## DOCUMENT CHANGE REQUEST

DCR number 334

Title: Matched Dual Transistors NPN, based on types 2N2919/2N2920 and 2N2920A

Number: 5207/002

### 1.6.1 Metal Can Package (TO-77) - 6 lead

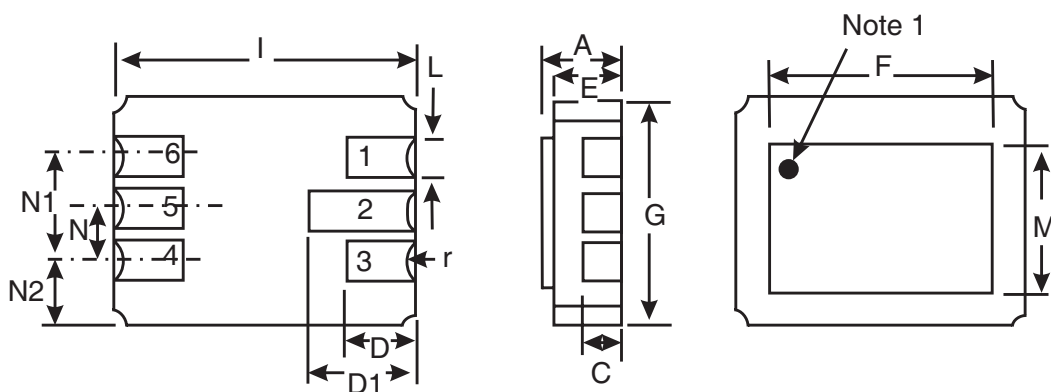
7. Para. 4.3.2 Weight requirements moved to Component Type Variants table.
8. Figure 2 re-named "Physical Dimensions and Terminal Identification"; Figure 2(a) amended to reflect the TO-77 package currently supplied; Figure 2(b) amended to reflect the CCP package currently supplied.
